Hill Chorlton Residents group

Response to “Chapel and Hill Chorlton parish: speeding on the A51 report”,

27 November 2020

Diagram showing the radar beam emitted from the front of a SID and covering the full width of the road.

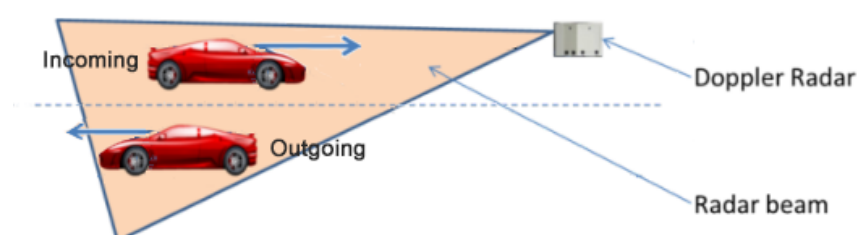
1.1 The report assumes that the SID measures the speed of traffic in only one direction:

"incoming traffic" relates to the speed of the vehicles as they enter the "SID Monitoring Zone" after exiting the bend, whilst "outgoing Traffic" relates to the speed of vehicles as they pass the SID on the straight section of the A51.

"Incoming" and "outgoing" in the reports generated from data captured by the SID refer to westbound and eastbound traffic, respectively.

"Incoming" traffic is approaching the SID from Chapel Bend and travelling west.

"Outgoing" traffic is moving east, away from the SID and towards Chapel Bend.

The display illuminates only for "incoming" (westbound) traffic, but vehicles travelling in both directions are recorded. (See diagram)
